ECN for USB Power Delivery Specification Revision 3.2

Version 1.1, 2024-10

Title: FRS update to discharge and detect disconnect

(a). Figure 10.3

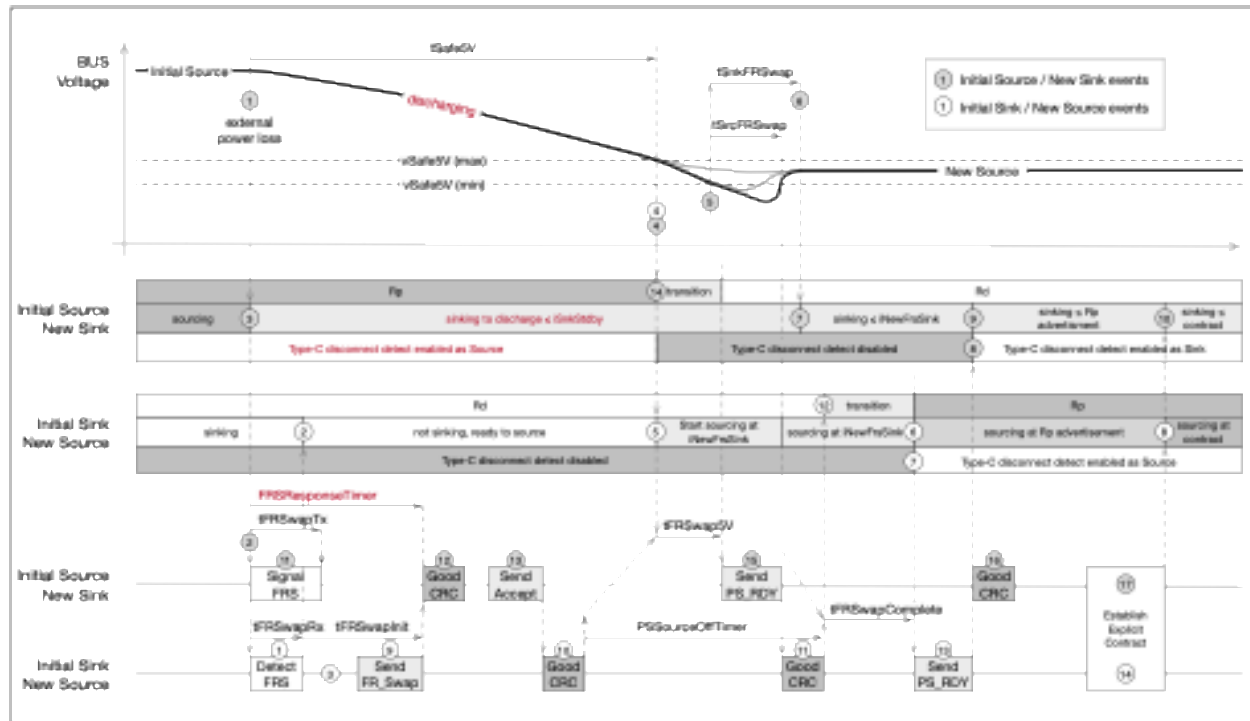
FRS as previously defined almost always would guarantee failure to complete. After reviewing known designs, these succeed because the FRS capable charge-through devices are not following the spec as it is written. This was because the required behavior in the spec (specifically PSSourceOffTimer requirement) was orphaned (not with the FRS description) and not implemented nor was it in compliance testing.

1. Requirement to not actively discharge when higher than vSafe5V (spec tried to hold this up as long as possible)
 - a. Conflicts with PSSourceOffTimer requirement
 - b. Not consistent with getting to a safe voltage quickly for a reattach.
2. Disconnect detect is not allowed after FRS signaling for the initial source and this can leave VBUS at a high voltage since not discharging if an actual disconnect occurs.
3. No requirement on the sender of the FRS signal to timeout receiving the FR_Swap message.

1. Add FRSResponseTimer (FRSResponseTime) that exactly matches tSenderResponseTime for responding with the FR_Swap message.
2. Correctly call out that when normal type-c disconnect detection is allowed
3. Add that the initial source should discharge VBUS just as in any power role swap or disconnect.

An FRS request is signaled by the Initial Source when it has lost external power and needs the Initial Sink to provide power to VBUS. The Initial Source Should signal the FRS as soon as it is aware that it has lost power. The following steps describe the behavior shown in the 'Signal FRS' activity diagram in Figure 10.2 and the timing diagram shown in Figure 10.3 and Figure 10.4 and match the numbers indicated in the figures.

3. At the same time as starting the FRS Signal, the Initial Source Shall stop Sourcing VBUS and Shall start sinking current $\leq i_{SnkStby}$ from VBUS. While $VBUS \geq v_{Safe5V} (max)$, the New Sink Shall sink enough current to discharge to $v_{Safe5V} (max)$ within t_{Safe5V} .

4. When $VBUS \leq v_{Safe5V} (max)$, the New Sink Shall continue to pull current to discharge VBUS to $v_{Safe5V} (min)$. This prevents the process from stalling where the New Source's threshold for $v_{Safe5V} (max)$ might be lower than the New Sink's threshold. The New Source might begin to source VBUS before reaching $v_{Safe5V} (min)$ resulting in VBUS staying above $v_{Safe5V} (min)$.

11. The FRS Shall be signaled by pulling low on CC for a length $t_{FRSwapTx}$.
12. After sending the FRS Signal, the Initial Source waits to receive an FR_Swap message. If the FR_Swap message is not received and responded to within $t_{FRSResponse}$, the New Sink Shall go to errorRecovery.
